From: [Raezer, Connie](#)
To: [Turcott, Mike \(UTC\)](#)
Cc: [Young, Betty \(UTC\)](#)
Subject: RE: [EXTERNAL] FW: 848701J - SR-6
Date: Wednesday, May 25, 2022 10:15:15 AM
Attachments: [image001.png](#)
[image002.png](#)
[22026 Midvale Signal - 5-18-2022.pdf](#)
[WSDOT Standard Plans for RR Crossing Layout m11.10-03 2019.pdf](#)

We need some additional information in order to assist the UTC in fully understanding and approving WSDOT's petition for the SR-6 crossing project.

HWY 6 - MIDVALE SIGNAL

PLAN
SITE PLAN

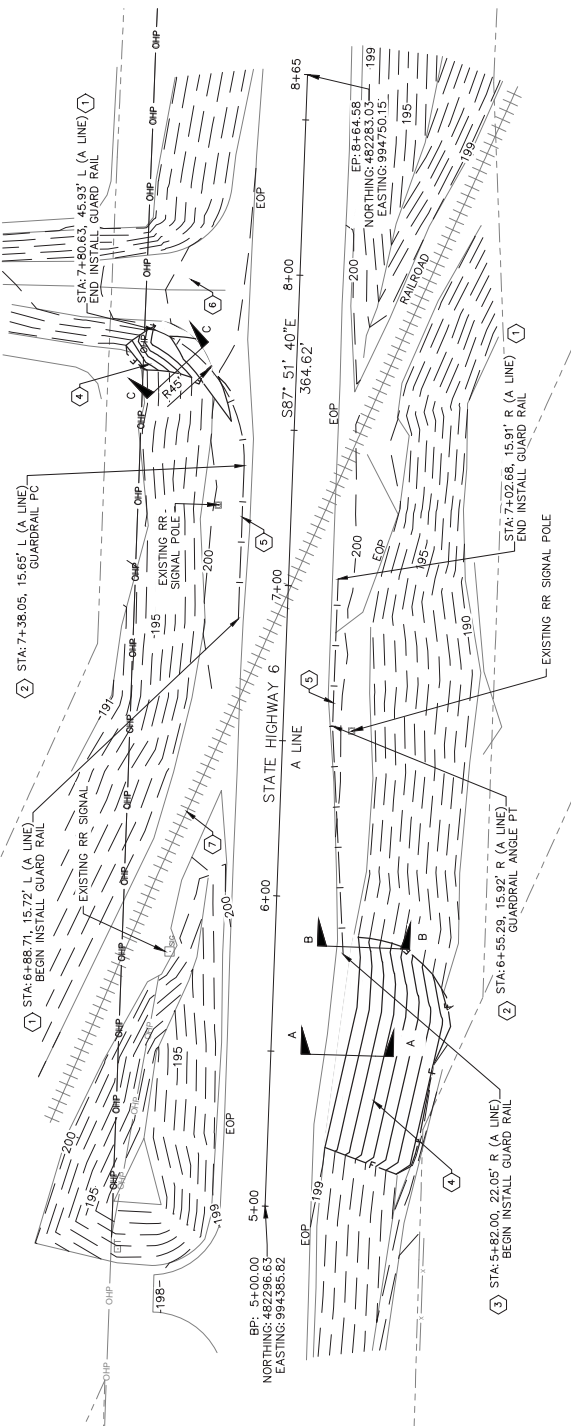
- Guardrail – **see attached plans**
 - Signage. – **see below**
- Does "install new signs" include replacement of existing advance warning signs, crossbucks, and ENS? Any other signs? (These should be indicated on the sign plan.) **Existing signage will be replaced with new crossbucks and warning signs. Current field installed advanced warning signs will be replaced with new. New bungalow will be provided with new ENS signs as well.**

said actual dimension may vary and to field verify. Per the railroad, new cantilevers were not called out. The signage and led flashers will be upgraded in the existing cantilevers. New gates will be installed on the track side of the cantilevers.

RAILROAD CROSSING LAYOUT

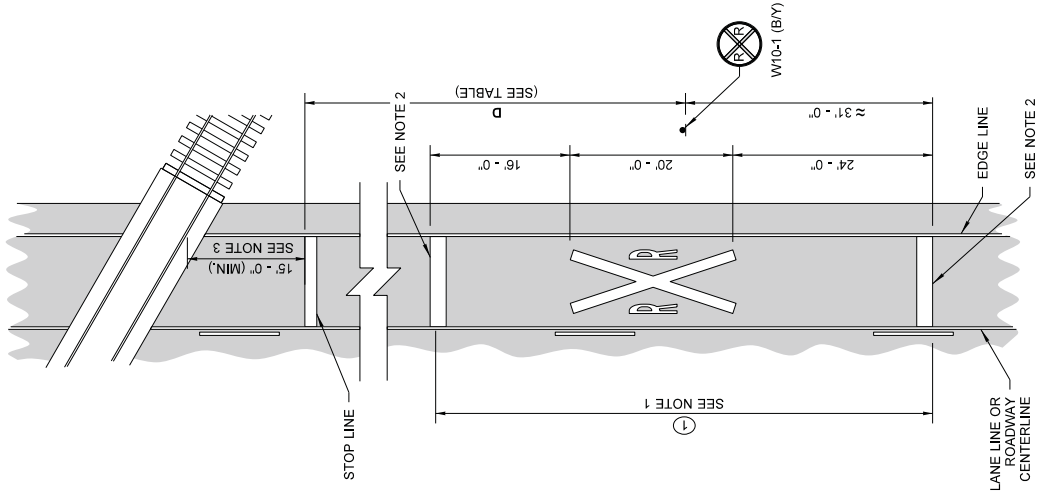
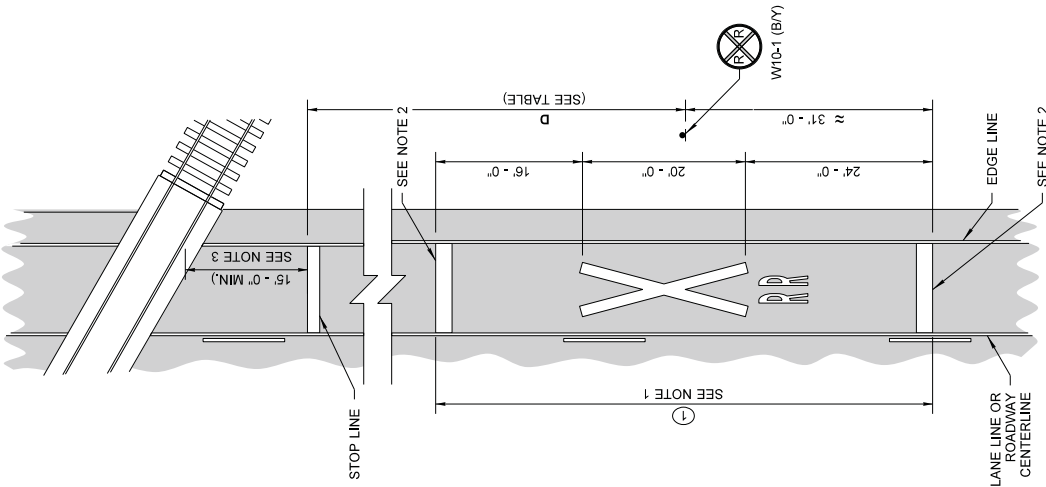
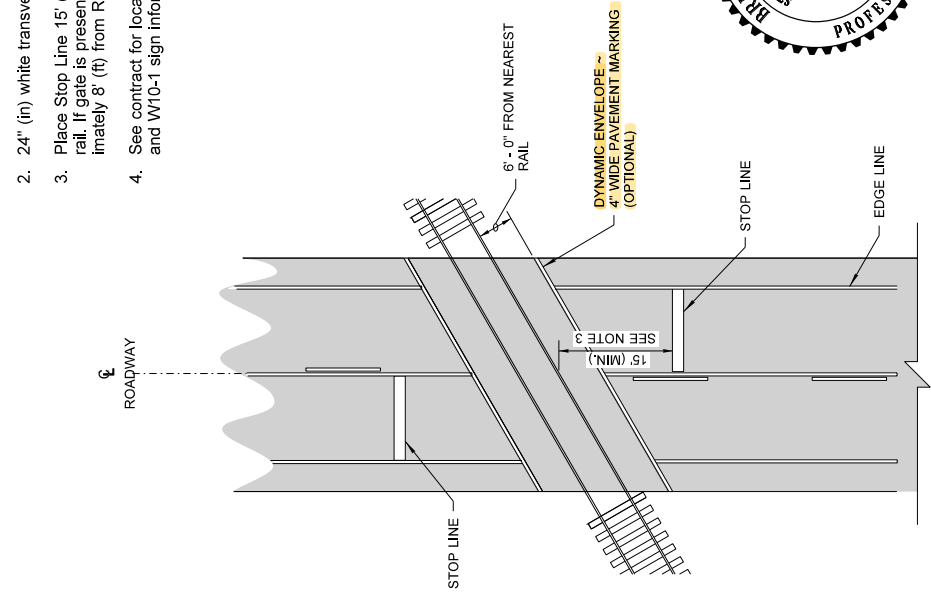
- Pavement – **There is no change to the pavement or crossing surface**
 - Pavement markings – **pavement markings will remain the same but be refreshed as needed (construction tends to tear them up). All markings will be in accordance with WSDOT standard plan attached.**
